**Re: DO SUMMERS PROPOSED PARKING LOT EXPANSION  
6447 WILSON MILLS ROAD**

I have reviewed the site plan submitted by North Coast Architects, Inc., dated June 22, 2023 for the proposed expansion of parking at DO Summers located at 6447 Wilson Mills Road. The requested parking lot expansion location is from the land banked parking spaces located in the front island, that were part of approved plans dated July 2002.

PARKING EXPANSION FOR:  
DO SUMMERS DRY CLEANERS  
& WHEELY CLEAN CAR WASH  
6447 WILSON MILLS ROAD  
MAYFIELD VILLAGE  
SITE PLAN  
2312

DATE: 22 JUNE 2023  
ISSUE: VILLAGE APPROVAL  
SP - 1

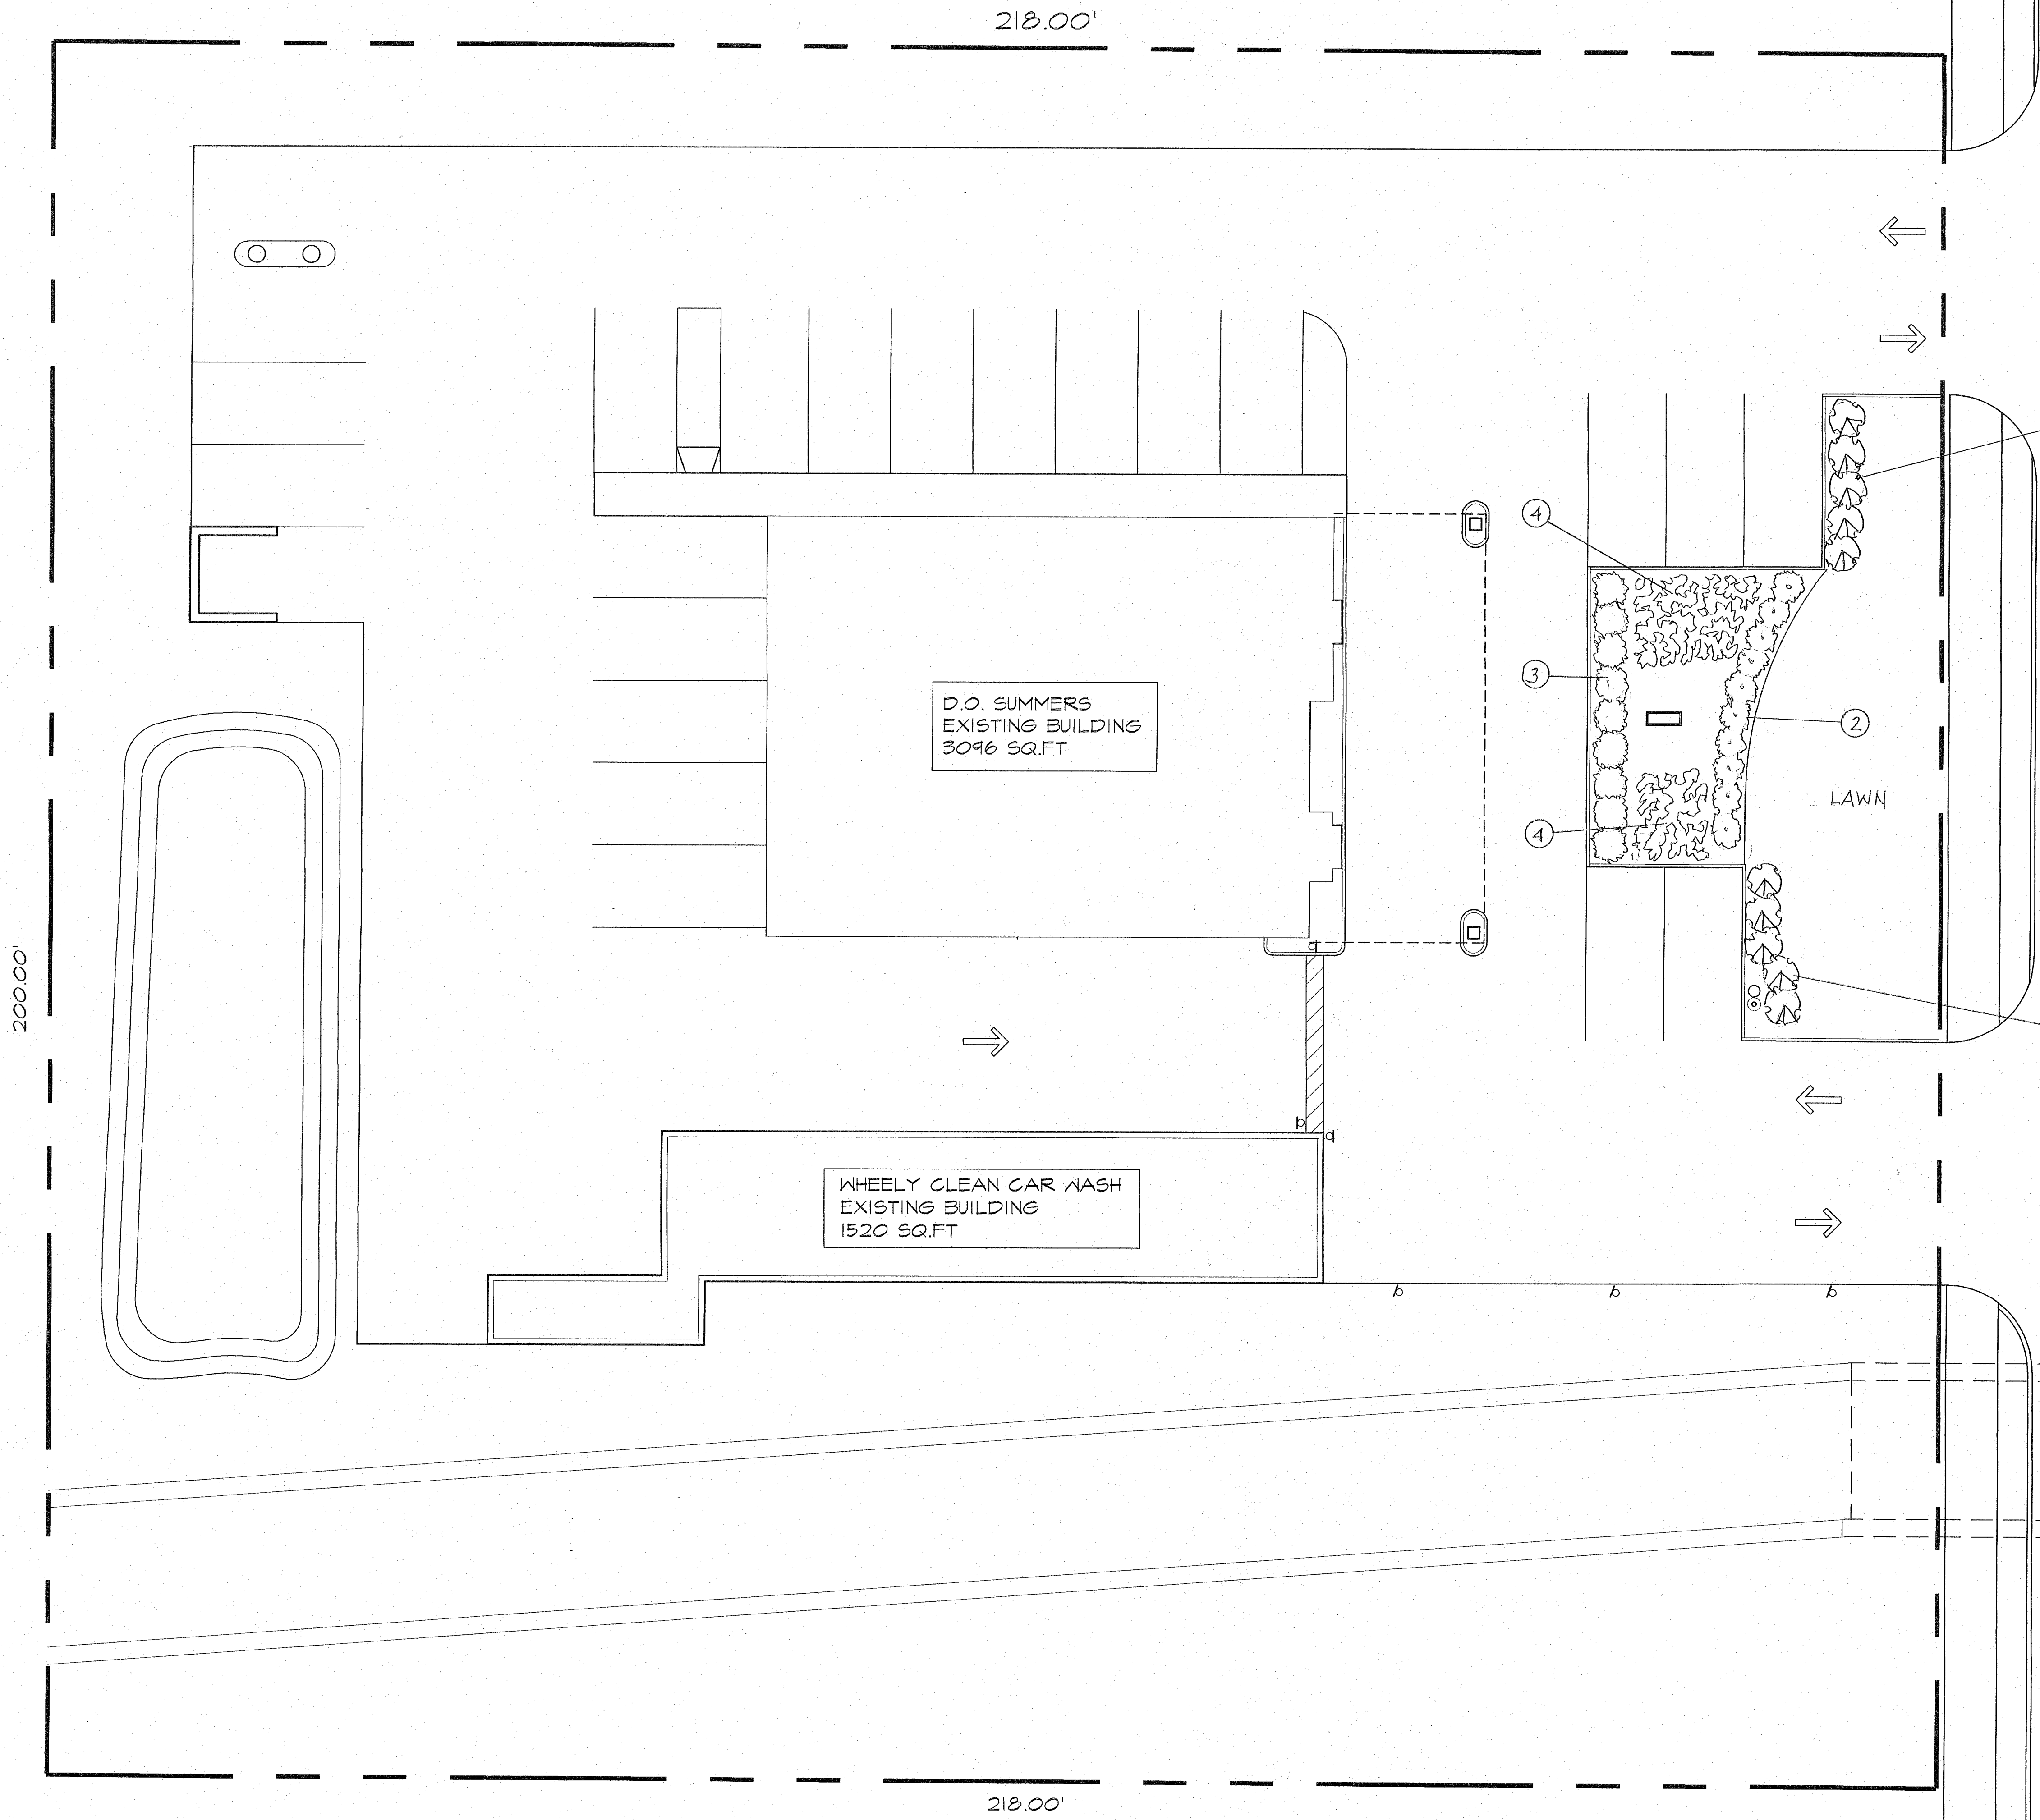
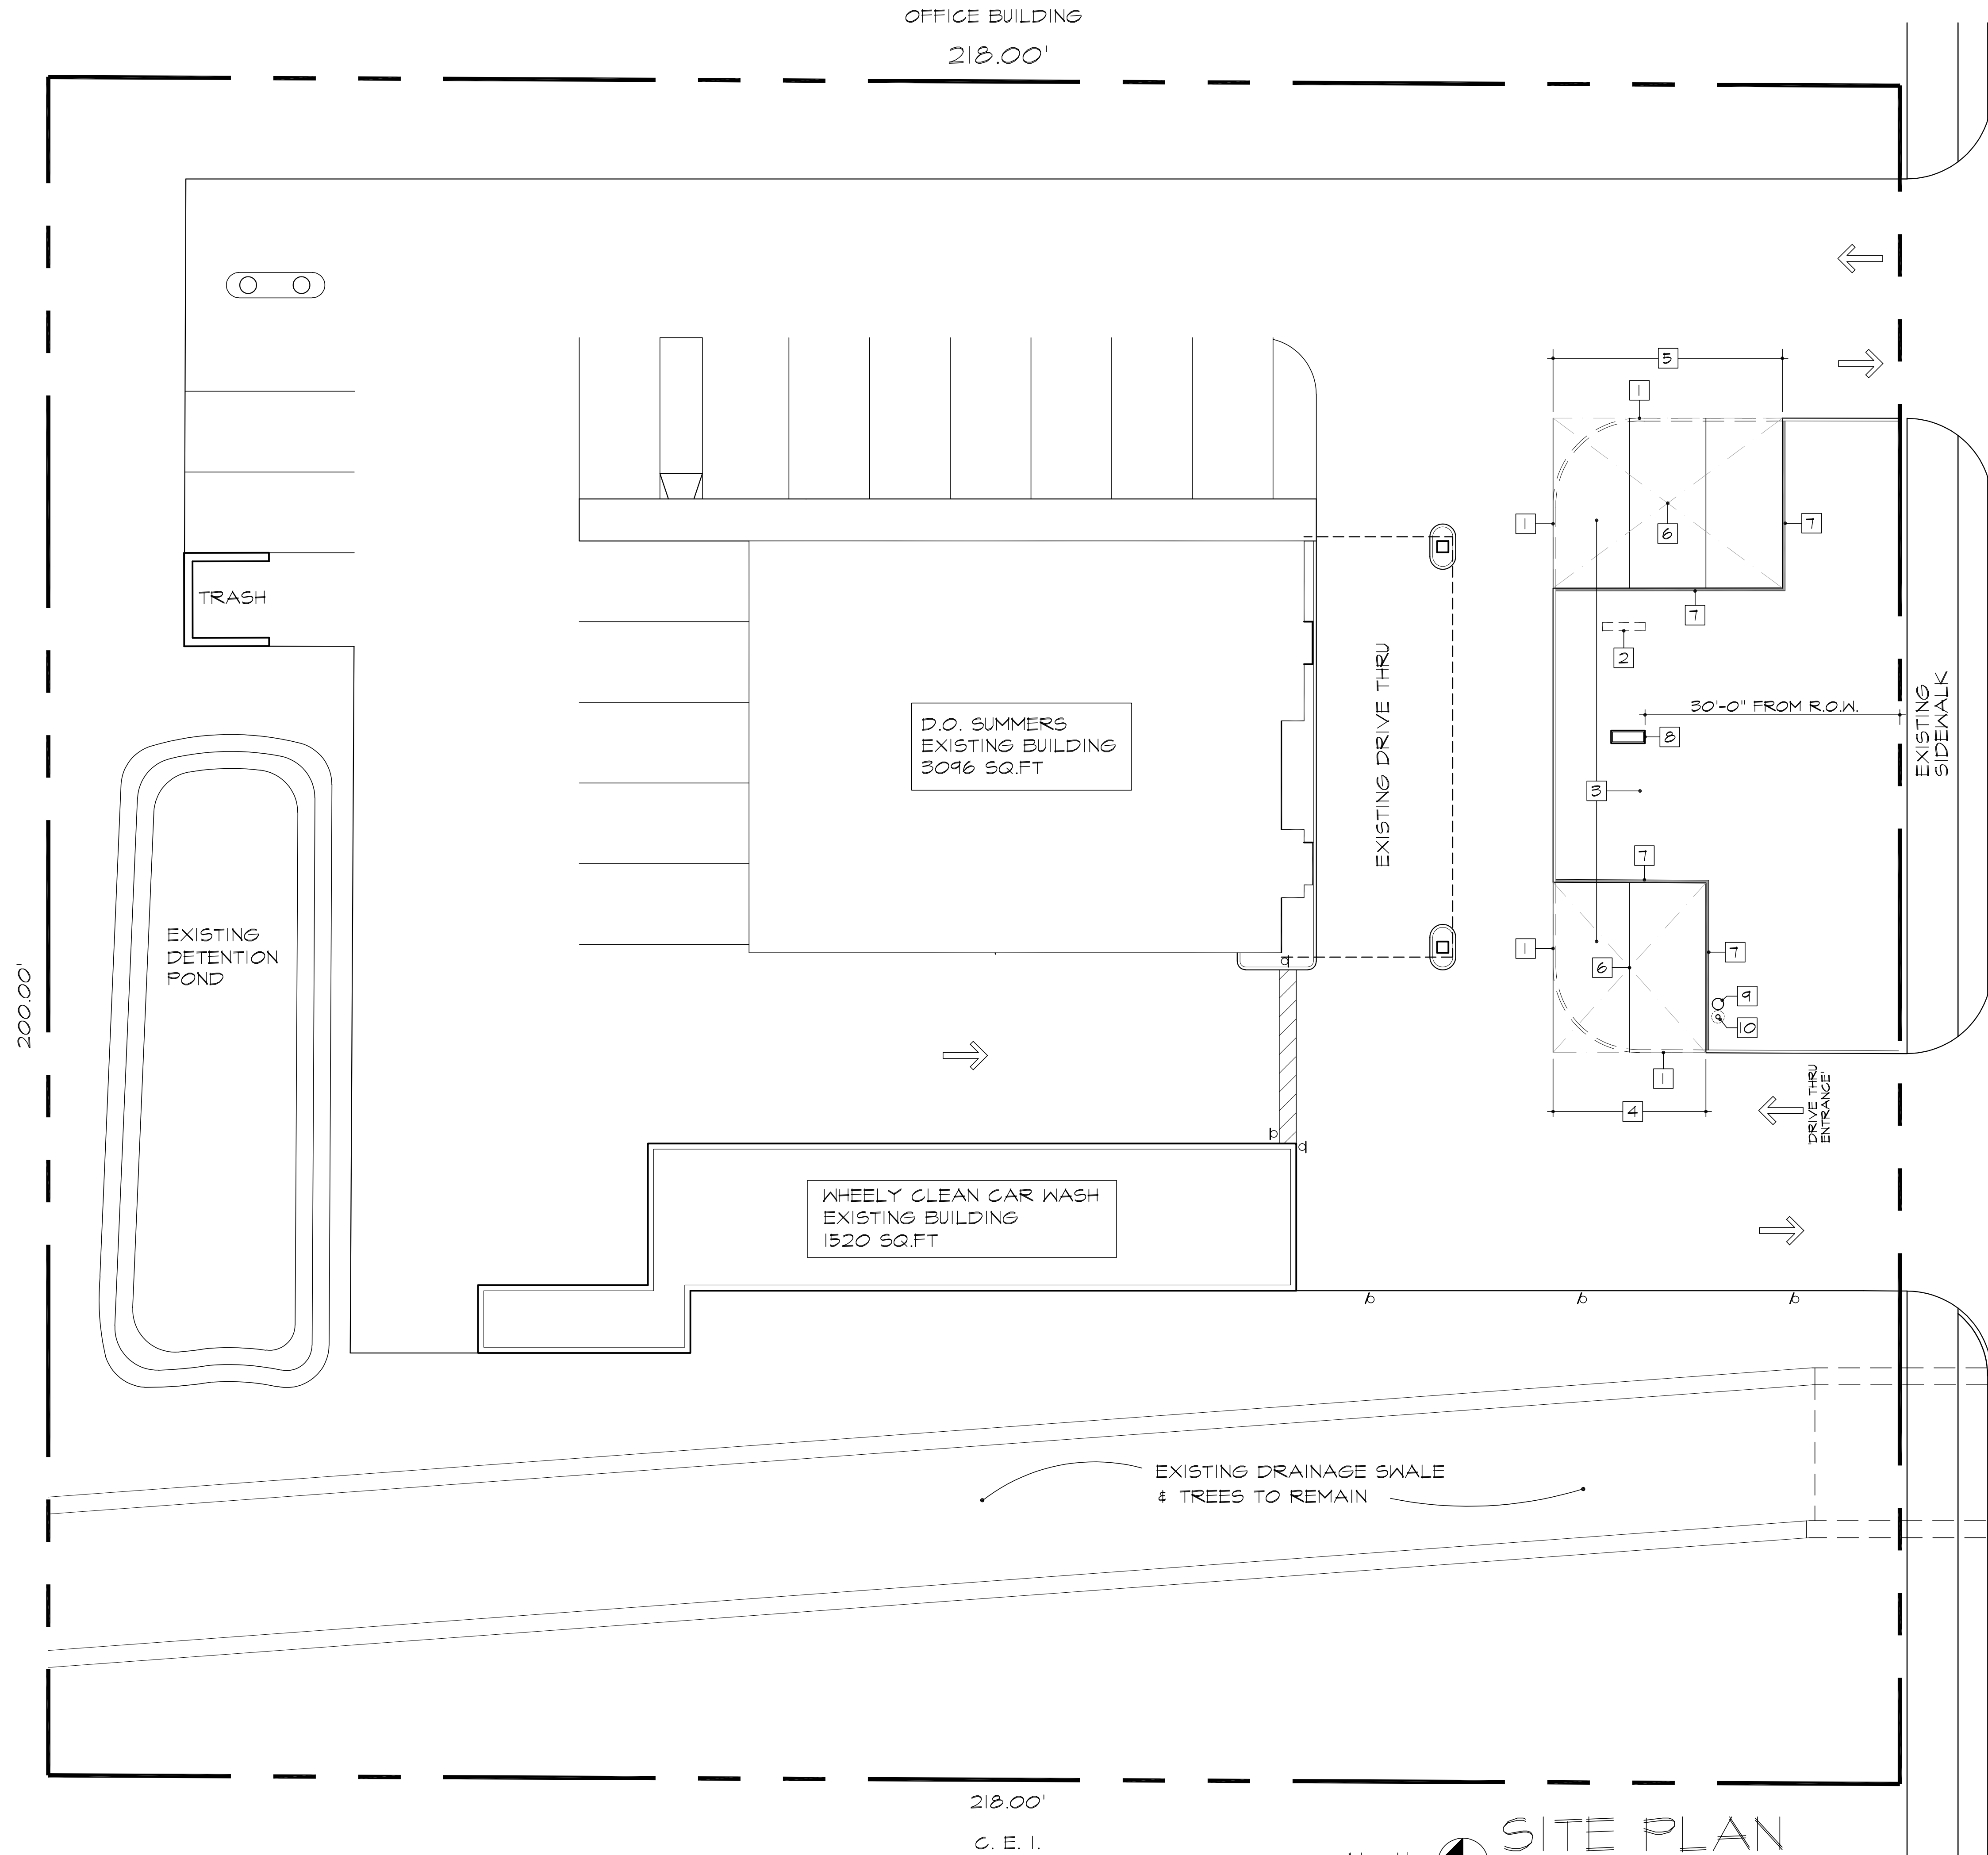
I will need a grading plan showing how the parking lot will drain storm water as well as pavement and other pertinent details.
